MEMORANDUM

Date: September 3, 2019
To: Design Review Board
From: Scott Guter, AICP, Senior Planner
File No.: DRV16-00914
Subject: **VILLAGE AT TOTEM LAKE – PHASE II (UPPER MALL)
MODIFICATION TO DRB DECISION**

PROJECT NAME: VILLAGE AT TOTEM LAKE - PHASE II (upper Mall)

GARAGE SCREEN

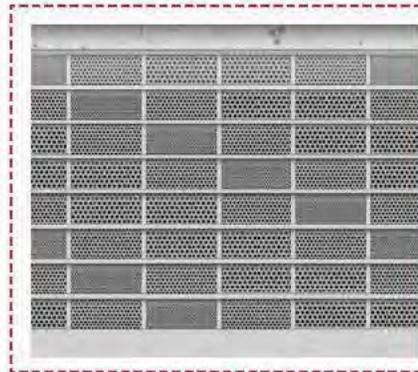
More information is still needed for proper review of the proposed garage screen as well as the garage entry doors. Material, finishes and in particular specificity on the perforation proposed is requested. Two styles of garage entry doors are shown in the inspiration images, define which one will be used.

More detail is provided for the garage screens as well as the garage entry doors. Both will be painted metal and the panels will be composed of perforated panels in varying sizes.

SECTION 1
BEFORE

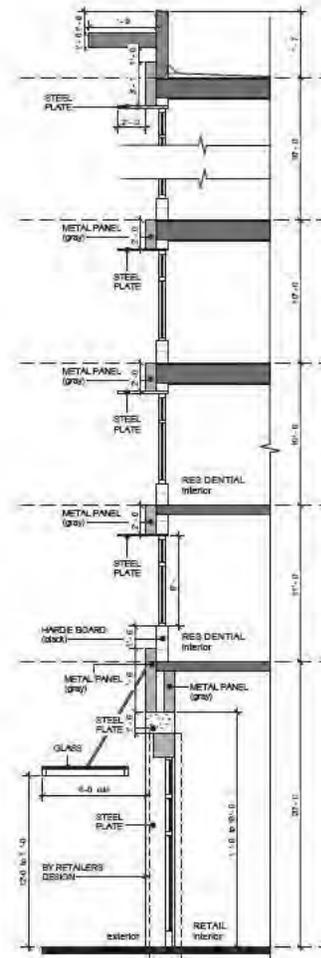
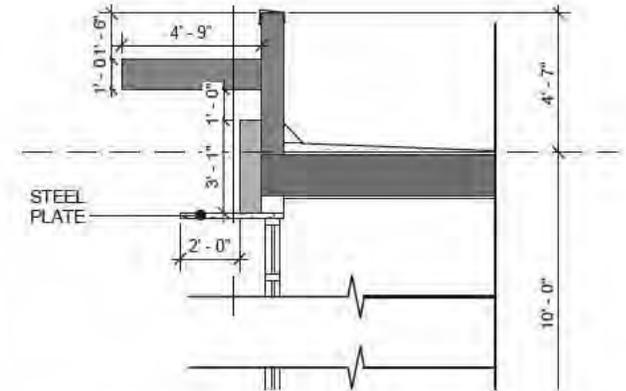
Roof lines need more refinement, some more finesse. Need to clarify the extent and dimensions of overhangs, cornices and parapets to be able to better evaluate the top elements

Wall sections have been extended to show the top of the various buildings and dimensions added to show extent of overhangs, eyebrows, etc. See example below

MECHANICAL SCREENING LOCATIONS

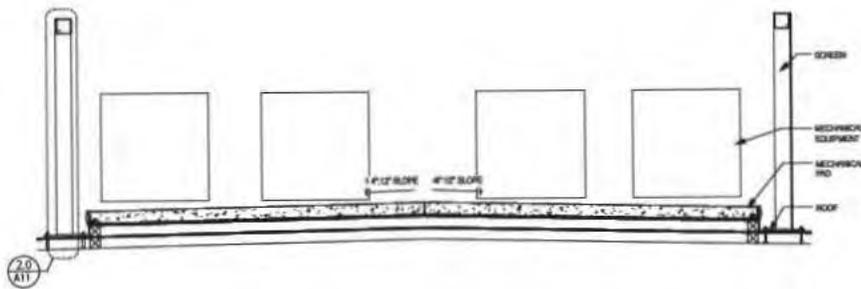
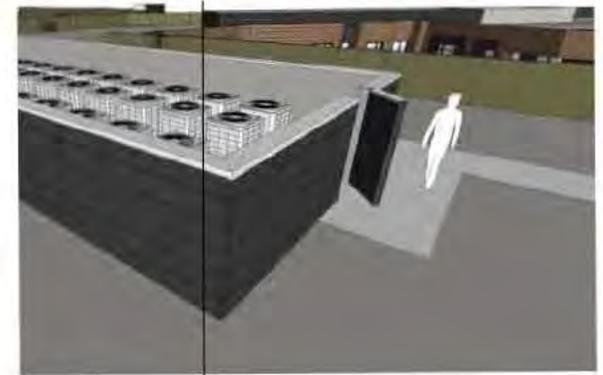
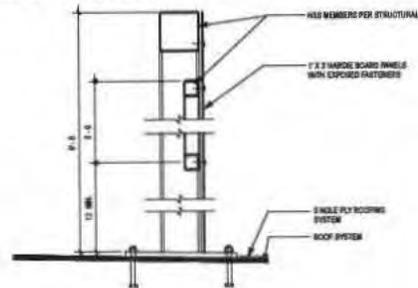
The idea of grouping the mechanical equipment on the roof and screening it is clever but would like to see more detail regarding the proposed screen, its material and height.

The roof mechanical screen are proposed in hardie board panels and will be 6 feet high. A typical detail has been provided.
